**RAI: Volume 3, Chapter 2.2.1.3.2, Number 1:**

**RAI Volume 3, Chapter 2.2.1.3.2, Number 2:**

**RAI Volume 3, Chapter 2.2.1.3.2, Number 3:**

**RAI Volume 3, Chapter 2.2.1.3.2, Number 4:**

Figure 1. Average Rockfall Pressure on the Sides and Top of the Drip Shield as a Function of the Density Multiplier

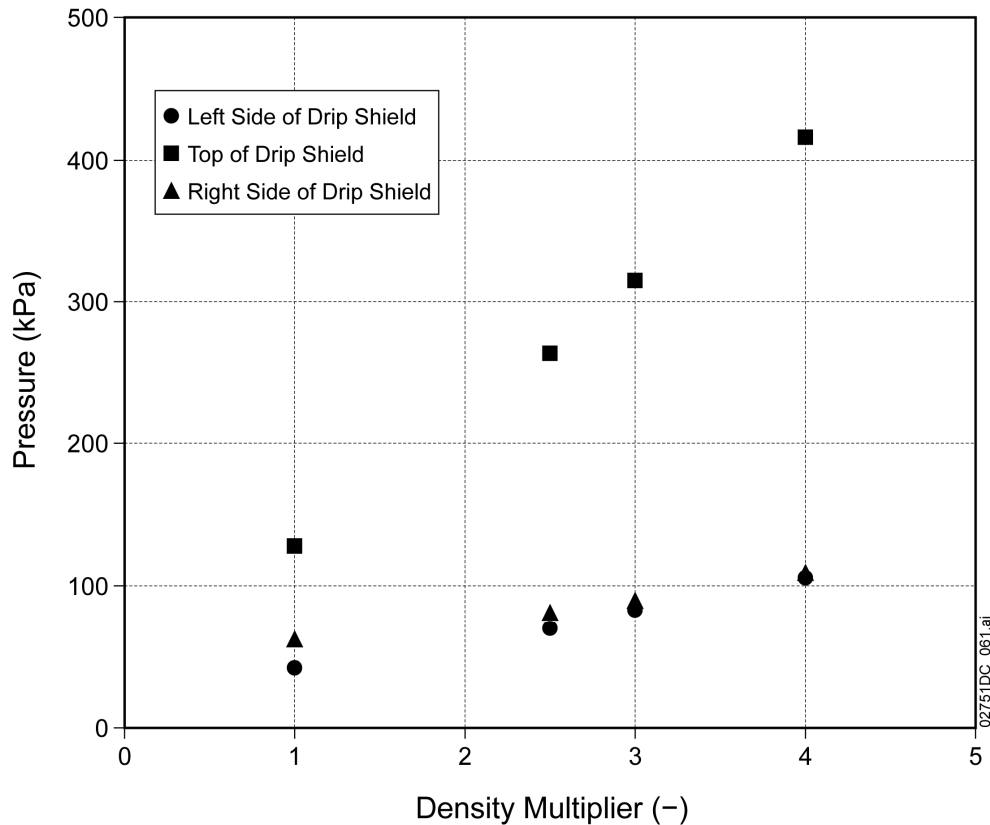
For the drip shield capacity assessment, provide a technical basis for not increasing the lateral loading as the vertical loading increases. This modeling assumption appears inconsistent with the implemented assumption that drip shield lateral resistance increases as vertical loading increases.

**Basis:** The model boundary conditions applied to the drip shield sides appear to unduly increase the structural resistance of the drip shield legs. To determine the system capacity, the model assumes the vertical loading of the original loading configuration can increase, but the active lateral rubble loading remains constant (SNL, 2007; Section 6.4.3.2.2.2). This assumption appears inconsistent with other information that indicates an expected increase in lateral load as the height of a rubble pile increases (e.g., BSC, 2004b, Table 5-29). Because of this modeling assumption, there is an increase in the tendency for outward deformation (i.e., “bowing”) of the drip shield legs as only the vertical load increases. The applicant counteracts the bowing by applying a reactive lateral resistance whose stiffness is a function of the elastic modulus of the rubble (SAR Section 2.3.4.5.3.3.2).

Figure 1 is a plot of the data in Table 2. Figure 1 demonstrates that the variability of the vertical rockfall load is much greater than the variability of the lateral rockfall load as a function of the density multiplier.

- The assessment of the plastic load capacity of the drip shield framework (SNL 2007a, Sections 6.4.3.2.2.2 and 6.4.3.2.2.3) focuses on vertical loading because the vertical load on the crown is the driving force for lateral buckling of the sidewalls and because the average vertical rockfall load is significantly greater than the average lateral rockfall load, based on the results in Figure 1.

Figure 1. Geometry of the Drip Shield Representations in LS-DYNA and FLAC3D Calculations

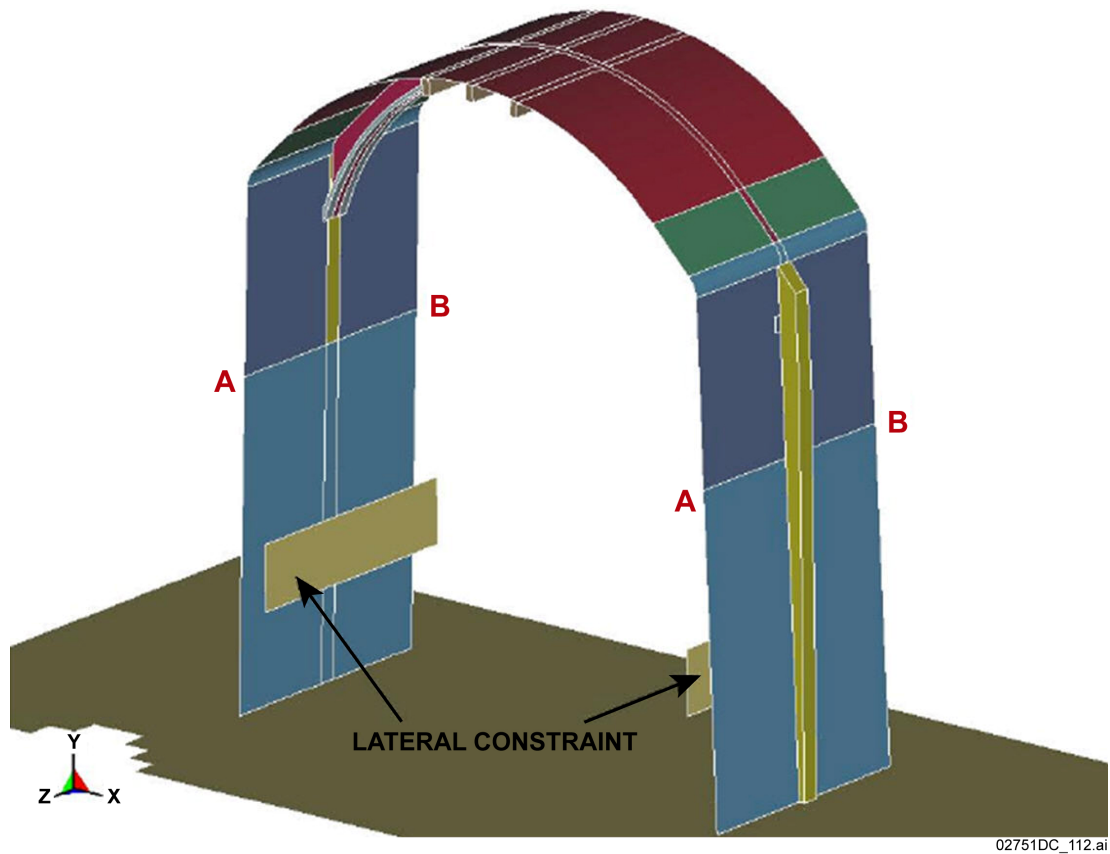
Demonstrate that the inclusion of model lateral constraints, representing the pallet base over the entire length of the drip shield, does not inappropriately bias the drip shield response in the analysis. Alternatively, provide a separate structural analysis for the drip shield segments that do not contact the pallet base.

**Basis:** The representative drip shield section of the applicant's model includes a lateral constraint to represent the base of the emplacement pallet (SAR Figure 2.3.4-74). The length of the base pallet, however, is approximately one fifth of the drip shield length.

The lateral constraint representing the pallet does not inappropriately bias the drip shield response in the analyses. It will be shown in this response that in most of the calculations the contact between the drip shield and the lateral constraint does not take place. It is also demonstrated that in the cases when the contact occurs, the waste package supports and the stainless steel tubes of the emplacement pallet can support the interaction force.

The lateral constraints, assumed to be rigid in the numerical representations, represent the emplacement pallet—specifically, the upper portion of the waste package support (pallet base) and the stainless steel tubes between the two waste package supports. The total length of the standard (long) pallet is 4.148 m. The length of two waste package supports at the pallet ends is 0.5429 m. Thus, the length of the stainless steel tubes between the waste package supports is 3.06 m. The discussion in this response is for the standard pallet, which accounts for approximately 90% of the pallets in the repository. The remaining 10% are the short pallets, 2.501-m long. The proportion of the repository length with the short pallets is less than 10%, because they are shorter than the standard pallets.

Figure 1. Average Rockfall Pressure on the Sides and Top of the Drip Shield as a Function of the Density Multiplier

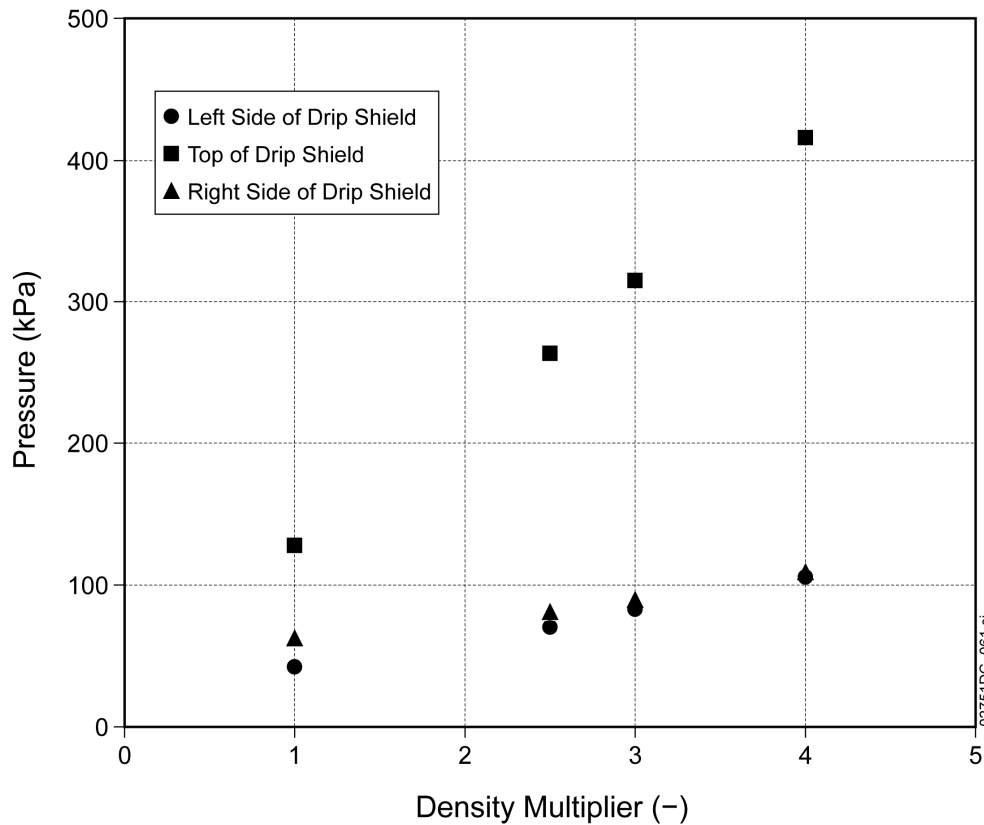
Provide a technical basis to demonstrate that the effect of loading configuration uncertainty on the drip shield capacity is appropriately represented by the two load cases used in SAR Section 2.3.4.5.3.3.2.

**Basis:** The applicant assessed drip shield performance under static loading using two loading configurations, which are derived from a set of six configurations for representing static rubble loading for complete drift collapse (SAR Section 2.3.4.5.3.3.2). The applicant used loading case 3, which the applicant stated is the most severe configuration, and the average of the six load cases. According to the applicant, the drip shield performance is relatively insensitive to different loading configurations and two loading cases are sufficient to characterize the system response. Nevertheless, analyses (BSC, 2004a) indicate that the lateral-to-vertical load ratio and asymmetry in the loading configurations may significantly modify the drip shield response.

Figure 1 is a plot of the data in Table 2. Figure 1 demonstrates that the variability of the vertical rockfall load is much greater than the variability of the lateral rockfall load as a function of the density multiplier. The assessment of the plastic load capacity of the drip shield framework (SNL 2007a, Sections 6.4.3.2.2.2 and 6.4.3.2.2.3) focuses on vertical loading because the vertical load on the crown is the driving force for lateral buckling of the sidewalls (as noted above) and because the average vertical rockfall load is significantly greater than the average lateral load, based on the results in Figure 1. Load realization 3 is then a reasonable choice for the maximum vertical rockfall load among the six realizations.

Figure 2. Plastic Load Capacity of the Drip Shield Framework as a Function of Plate Thickness and Boundary Conditions

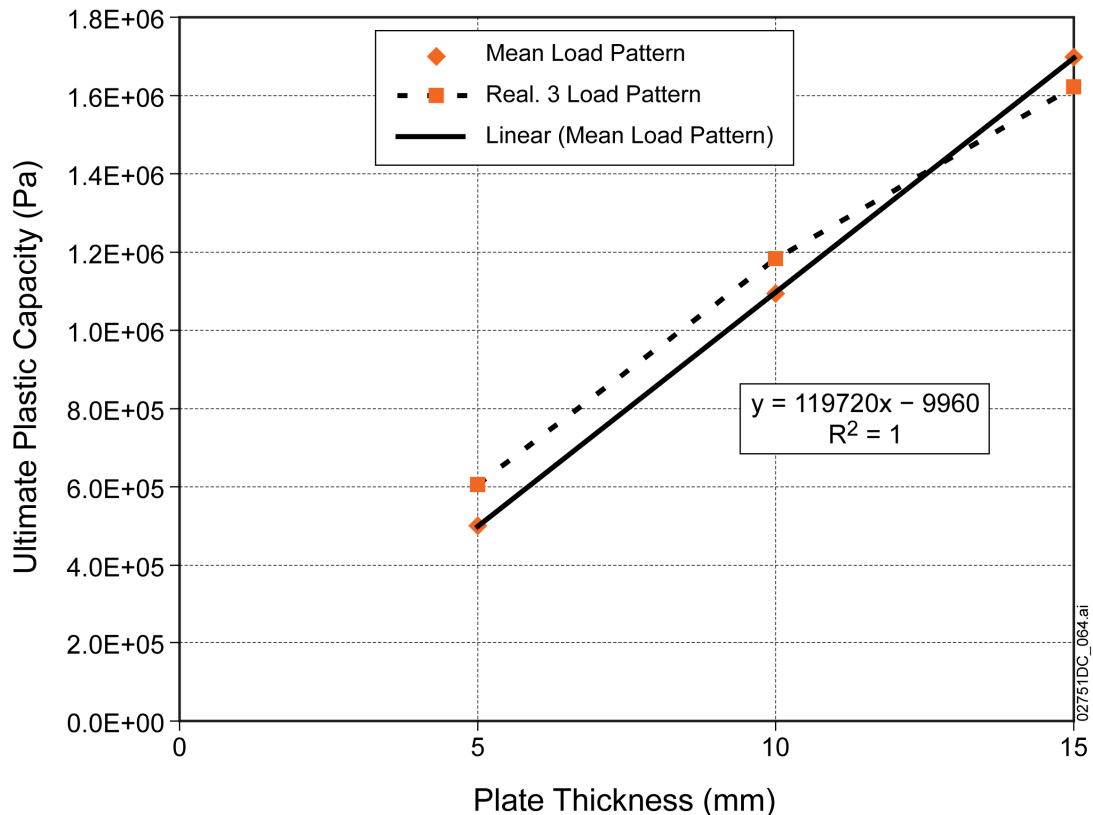
Provide a technical basis to select the most severe loading configuration with respect to drip shield capacity based solely on the vertical loading, a selection that does not account for the potentially significant effects of lateral loads.

**Basis:** The applicant indicates that loading case 3 is the most severe among the six computed realizations (SAR Section 2.3.4.5.3.3.2) because case 3 has the highest average vertical load (SAR Section 2.3.4.5.3.2.1). Case 3, however, has one of the smallest lateral-to-vertical load ratios of the six cases (SNL 2007, Table 6.136). As observed in SAR Figure 2.3.4-83, this load configuration is not the most severe case for buckling failure (i.e., cases with plate thinning of 5 and 10 mm).

The quasi-static calculations for plastic load capacity of the framework, which are the basis for Figure 2, have a change in failure mode between plate thicknesses of 10 mm and 15 mm. The observed failure modes are snap-through of the crown of the drip shield for the 15-mm thick plates and buckling of the sidewalls of the drip shield for the 5-mm and 10-mm thick plates. This change in quasi-static failure mode explains the crossing of the curves observed in Figure 2. The observation that load realization 3 has greater plastic load capacity for the corroded states of the drip shield indicates that lateral load has an influence on the bowing and buckling of the drip shield side walls in the quasi-static analysis.

Figure 2. Displacement Vector Field (m) at the End of Simulation for 50° Friction Angle and No Surcharge by the Rubble outside the Drip Shield

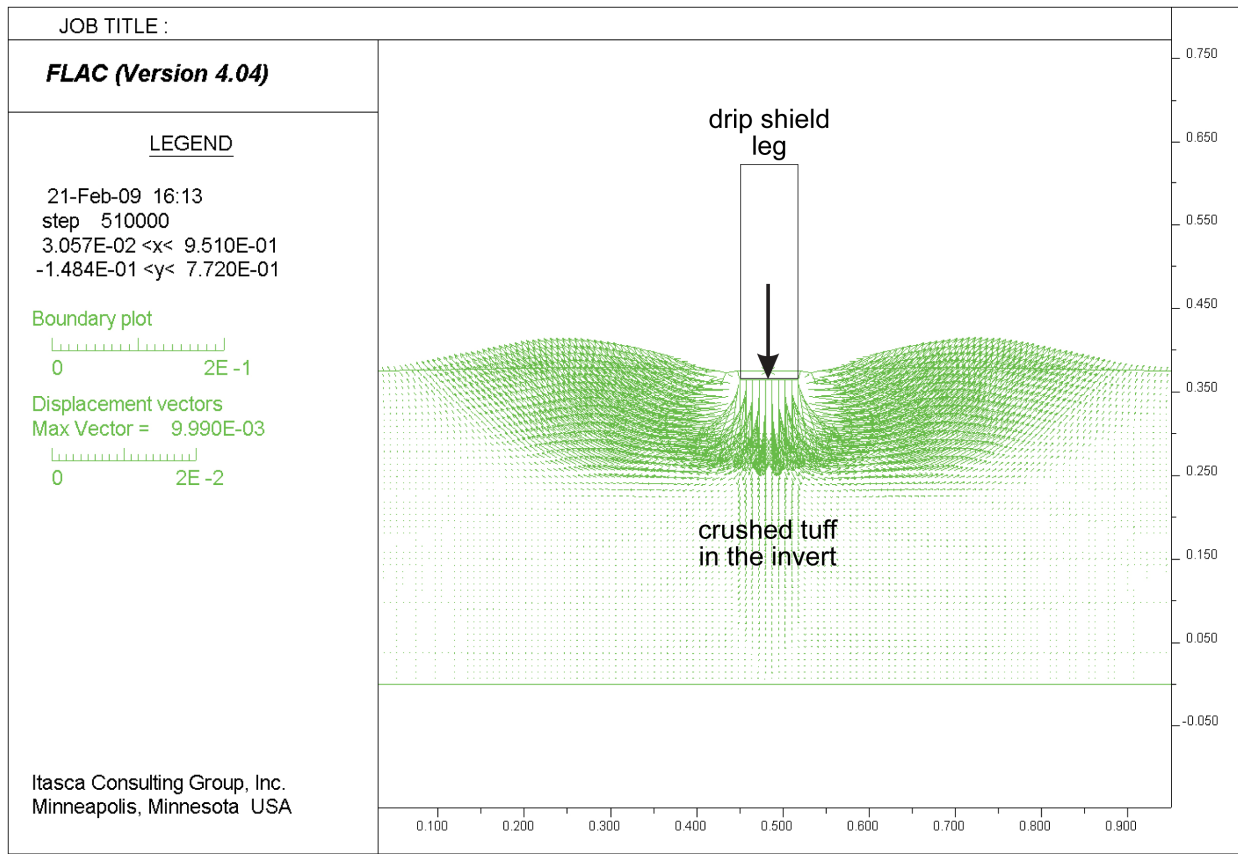
Demonstrate that additional deformation of drip shield due to the uneven degradation of the invert does not decrease the drip shield capacity. Also, provide the bearing capacity and settlement calculations for the invert.

The analysis of the invert bearing capacity and settlement, when the steel substructure has corroded away, was carried out using numerical code FLAC Version 4.04 (STN: 10167-4.04-00). The problem was simulated as a rigid punch 75 mm wide, which is the width of the drip shield base. The punch indented into a half space—i.e., the crushed tuff in the invert, at a constant but small velocity (to ensure quasi-static conditions). The analyzed geometry and the displacement vector field at the end of simulation for one analyzed case (i.e., 50° friction angle of crushed tuff and with no surcharge pressure outside of the drip shield) are shown in Figure 2. The input parameters used in the calculations are listed in Table 1. The dilation angle was assumed in all calculations to be 10°, in general agreement with data in published literature (e.g., Korkiala-Tanttu and Laaksonen 2004, Table 2).
